Austin Service Journal Bulletins 1960

Compiled by J. Scott Morris [jstmorris@yahoo.com]

DISC BRAKES

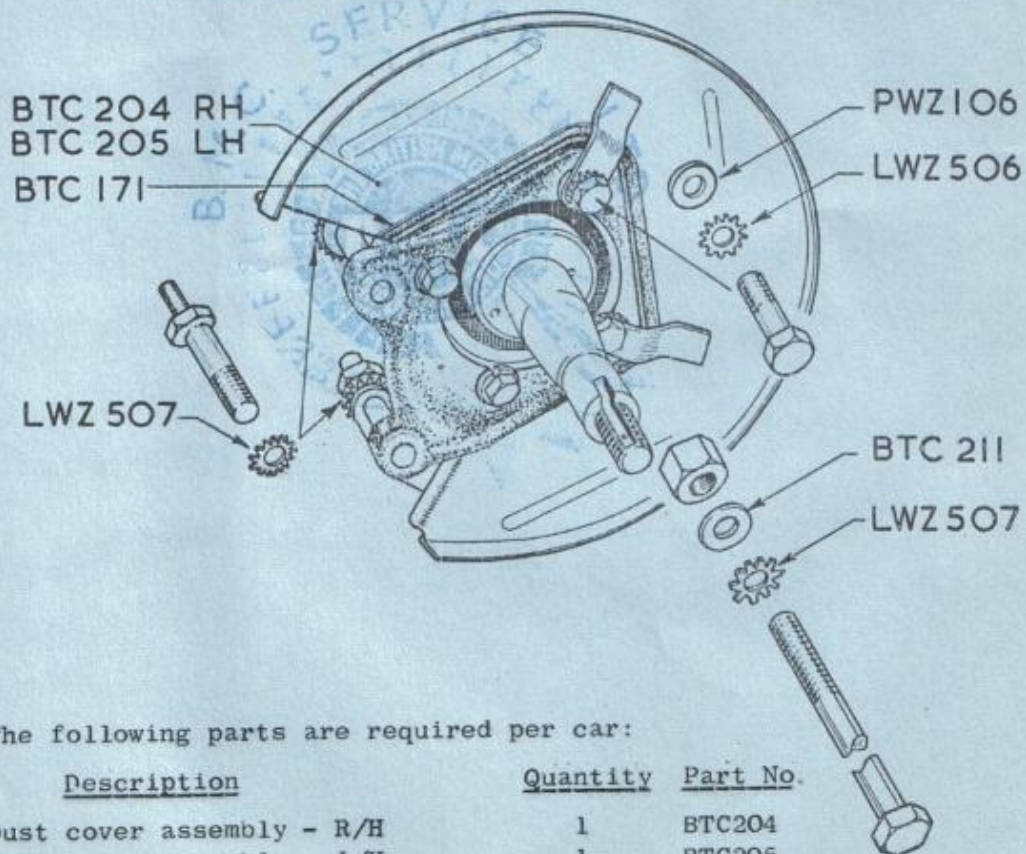
1. Wear of inner pads may be due to water and road grit. It can be prevented by fitting dust covers, Part No. BTC204 (R/H) and BTC205 (L/H), with rubber seals, Part No. BTC171, as shown in the sketch below.

SQUEAL FROM DISC BRAKES

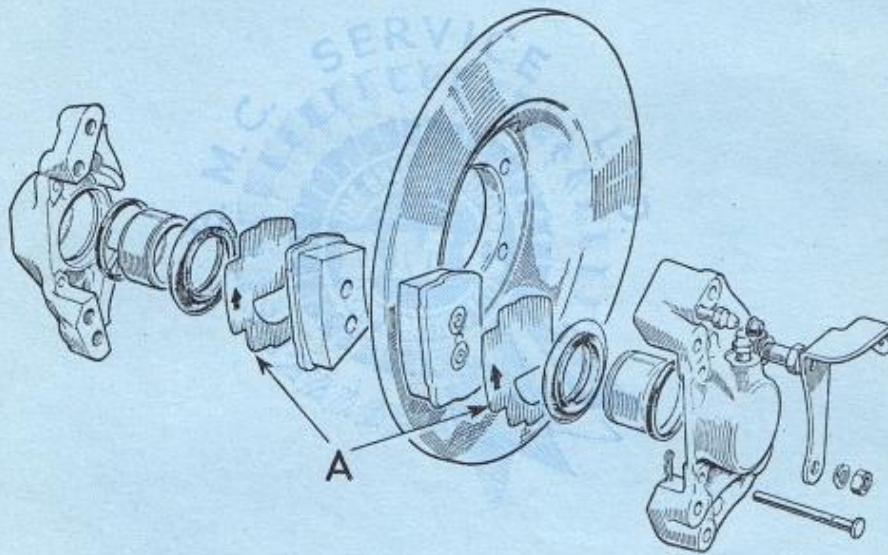
This may be prevented by fitting four anti-squeal shims, Part No. BHA4195, which should be positioned between each of the brake pads and pistons, with the arrow mark pointing in direction of forward rotation of wheel, as shown at 'A'.

TIMING CHAIN TENSIONER

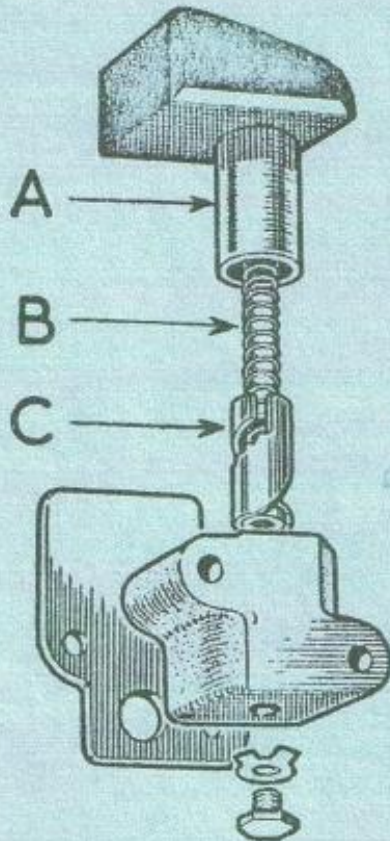
This assembly, which consists of the slipper head ('A' in sketch), spring 'B' and plunger 'C', may be used as a replacement in the original body, provided that the latter is not damaged or unduly worn.

If the mouth of the bore of the body has worn oval by more than .003" (.76 mm.), then the body should be scrapped and a complete new tensioner fitted.

SUMP PROTECTION PLATE

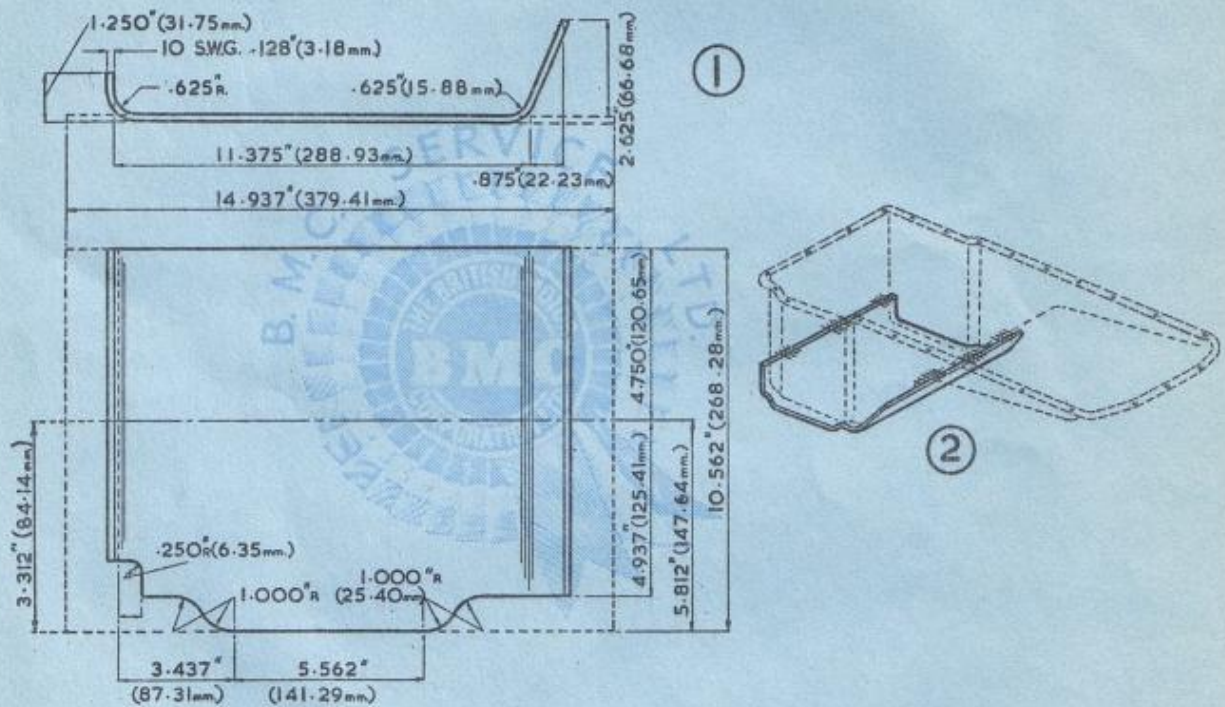
To prevent sump damage in very rough country, a mild steel protection plate (Fig. 1) may be welded to the sump in six places (Fig. 2)

Sumps should be drained and removed before welding. Arc-welding is preferable if distortion is to be avoided and Sifbronze will also enable a satisfactory job to be made.
